CITY COUNCIL STAFF REPORT

PALM SPRINGS, LLC, REQUEST FOR FINAL PDD PLAN APPROVAL FOR PLANNED DEVELOPMENT DISTRICT 324 TO CONSTRUCT A MIXED-USE DEVELOPMENT CONSISTING OF A 150-ROOM HOTEL, COMMERCIAL SPACE AND PARKING STRUCTURES AT 400 NORTH

PALM CANYON DRIVE, ZONE PD324, (CASE 5,1091 / PD-324).

PALM CANYON ELEVATION

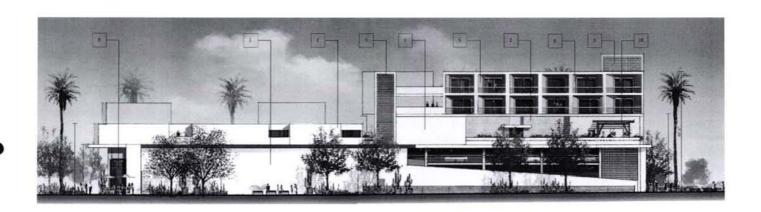
Although less successful than the other changes to the elevations, the Palm Canyon storefronts have been revised to include columns faced with chiseled limestone veneer and the use of an accent color ("Melted Copper") on the continuous horizontal member of the storefront system above the retail entrance doors. The pedestrian entrance to the public parking garage along the Palm Canyon frontage has also been greatly enhanced, and becomes more prominent in the center of the retail storefronts.
